ADD26486
APPROVED 400 SQ FT - DECK WITH COVER

PROJECT DATA:
SCOPE OF WORK: BUILD NEW 20' X 20' COVERED DECK
ADDRESS: 15930 FOOLS GOLD LANE, COLORADO SPRINGS
ZONING: RR-5
PLAT #: R00869
LEGAL DESC.: LOT 19 BLK 3 BLACK FOREST PARK SUB
AREAS:
LOT = 165,528 SQ.FT.
EX. HOUSE + GARAGE COVERAGE = 3150 SQ.FT.

DATE:
8/12/2026
SCALE:
1" = 30'-0"
SHEET:
A-1

SITE PLAN

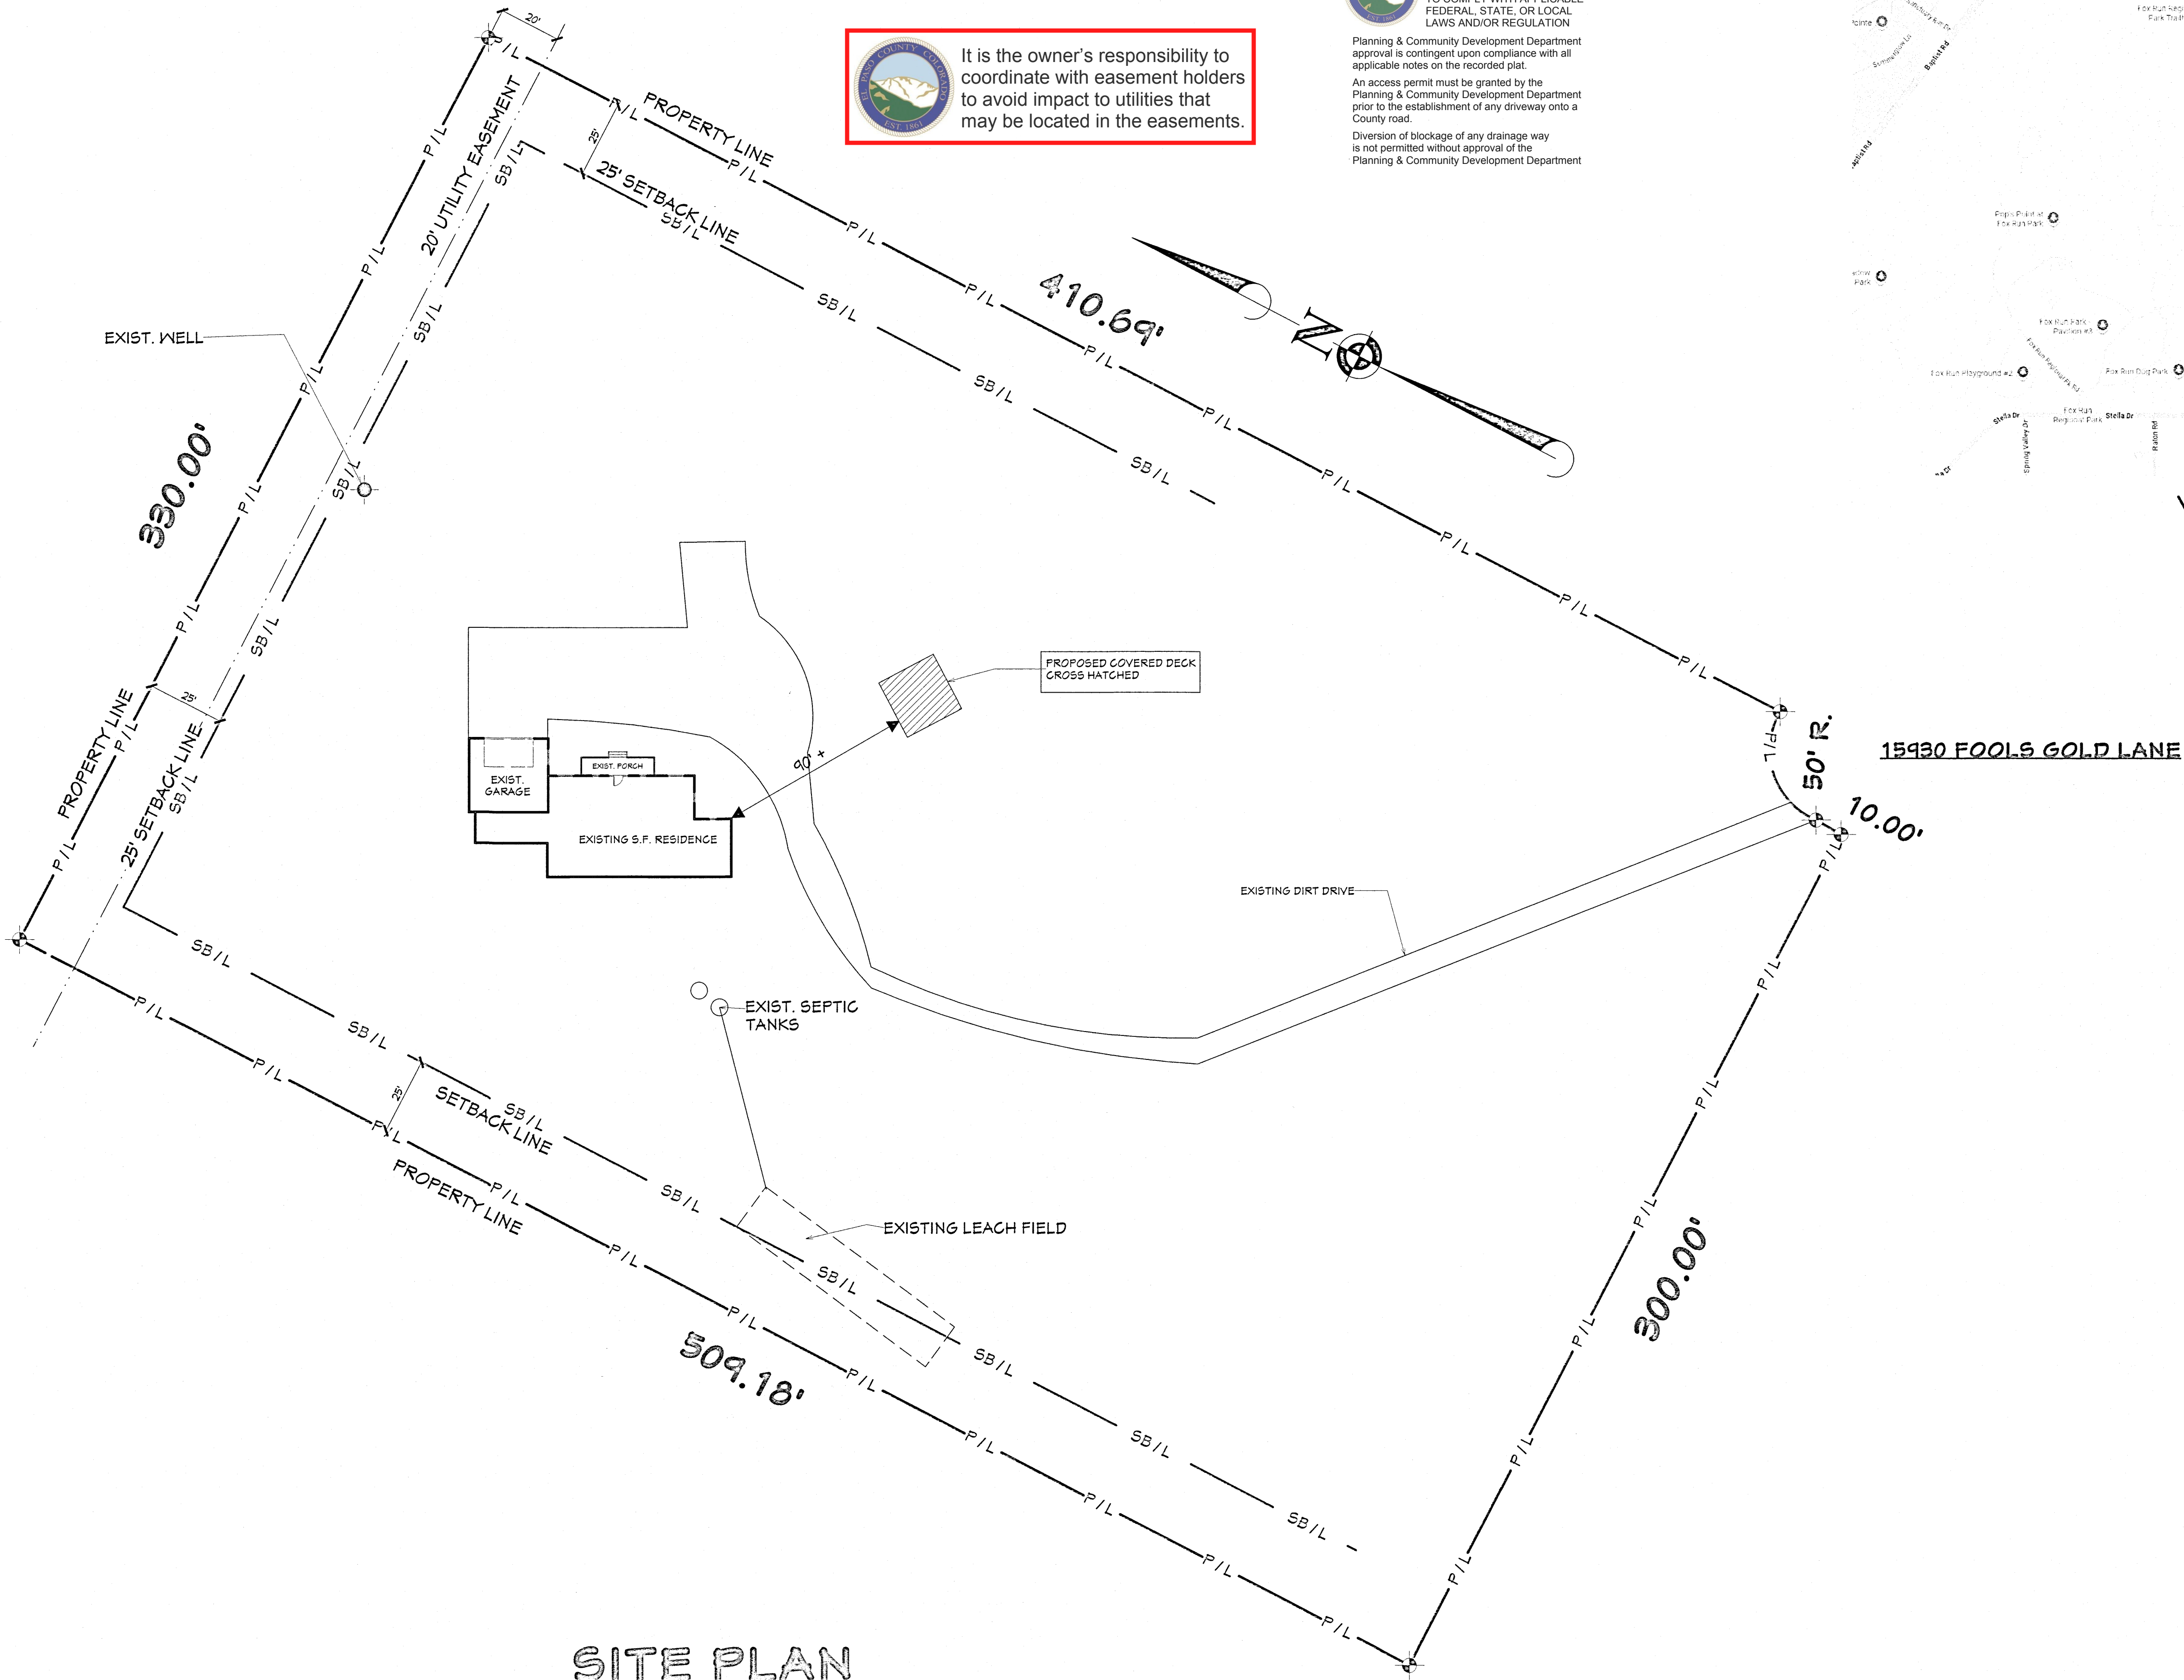
This parcel is in a low/moderate/high intensity fire risk area. Please reach out to the local fire district regarding recommendations for compliance with the WRC code.

It is the owner's responsibility to coordinate with easement holders to avoid impact to utilities that may be located in the easements.
